SUNDRY NOTICES AND REPORTS ON WELLS
Do not use this form for proposals to drill or to re-enter an abandoned well. Use form 3160-3 (APD) for such proposals.

8. Well Name and No.
SMALLS FEDERAL 2H ✓

9. API Well No.
30-025-43064-00-X1

WELLS IN THIS AREA HAVE SUGAR SAND BETWEEN BOTTOM OF SALT AND TOP OF YATES. COG OPERATING LLC RESPECTFULLY REQUESTS PERMISSION TO ADD 11.75# 47# J-55 BTC SET AT 3750' TO CASE THE SUGAR SAND OFF. THIS WILL REQUIRE INCREASING SURFACE CASING SIZE TO 16" 75# J-55 BTC SET AT 2130'. THIS WILL ALSO REQUIRE DECREASING THE SUBSEQUENT CASING TO 8 5/8" 32# HCL-80 BTC @ 5250' (WITH DV/ECP @ 3915').

Proposed WBD

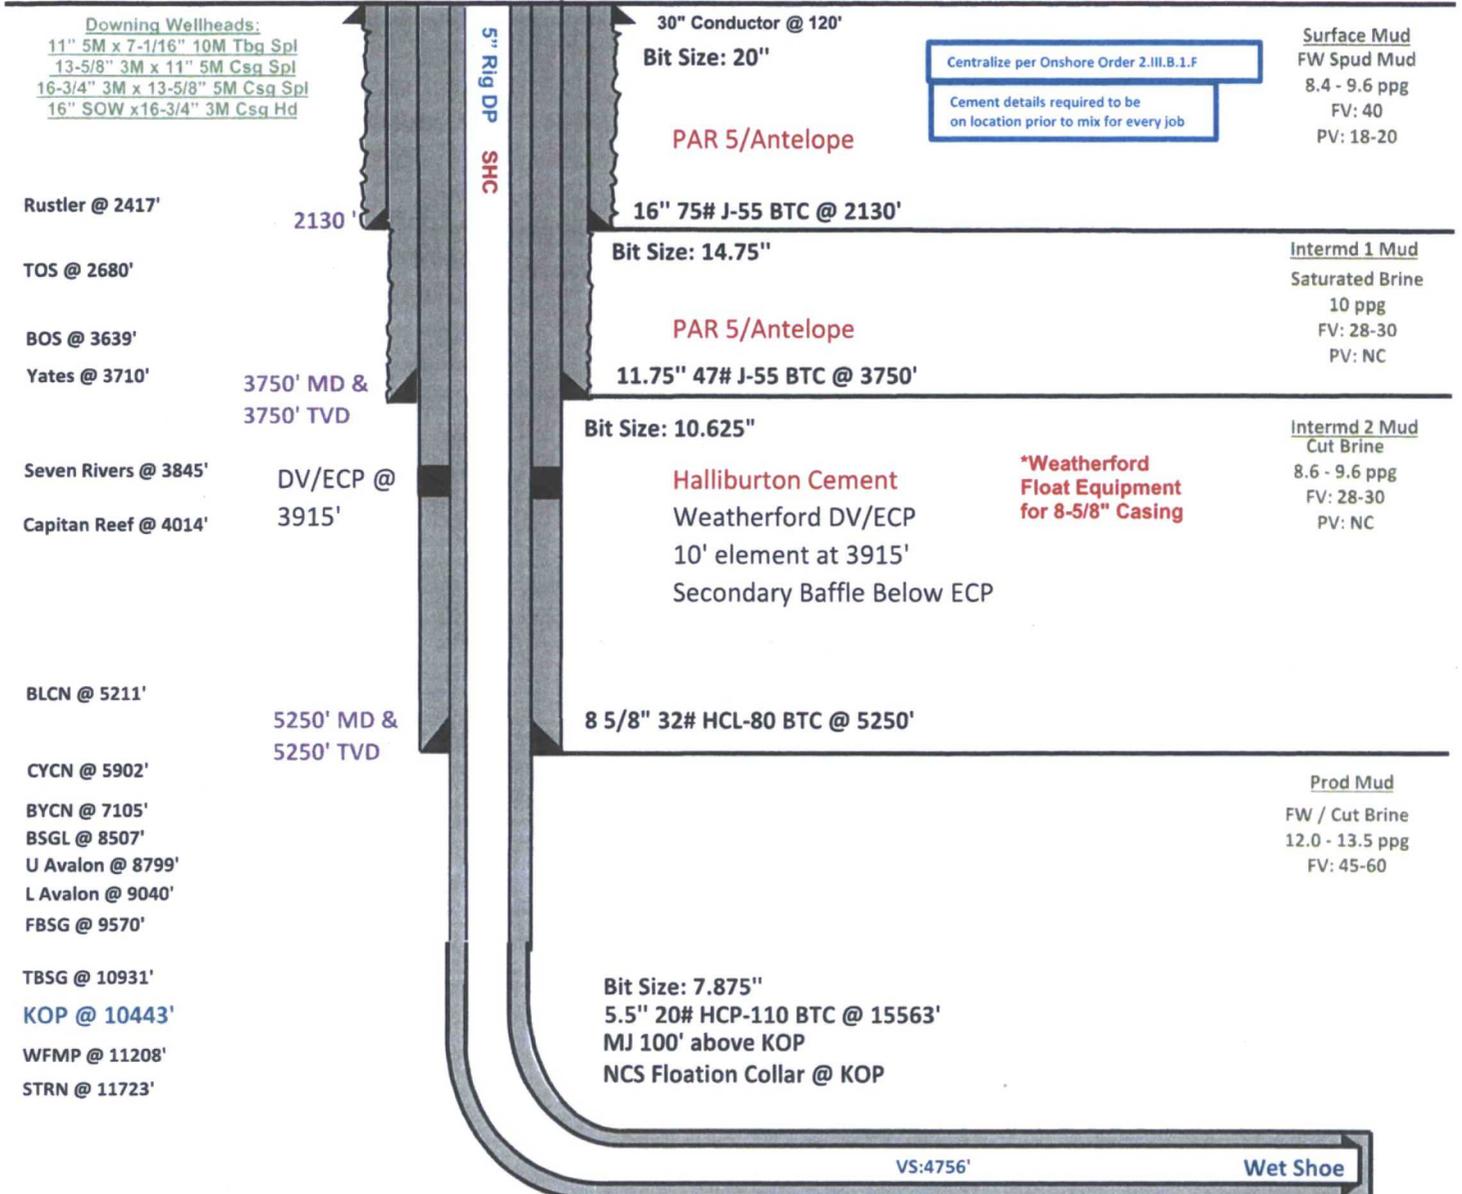
**** BLM REVISED ** BLM REVISED ** BLM REVISED ** BLM REVISED ** BLM REVISED ****

1. The 16 inch surface casing shall be set at approximately 2130 feet (a minimum of 25 feet into the Rustler Anhydrite and above the salt) and cemented to the surface.

2. The minimum required fill of cement behind the 11 3/4 inch first intermediate casing, which shall be set at approximately 3750 feet, is:

3. The minimum required fill of cement behind the 8 5/8 inch second intermediate casing is:

Operator has proposed DV tool at depth of 3915', but will adjust cement proportionately if moved. DV tool shall be set a minimum of 50' below previous shoe and a minimum of 200' above current shoe. Operator shall submit sundry if DV tool depth cannot be set in this range. If an ECP is used, it is to be set a minimum of 50' below the shoe to provide cement across the shoe. If it cannot be set below the shoe, a CBL shall be run to verify cement coverage.
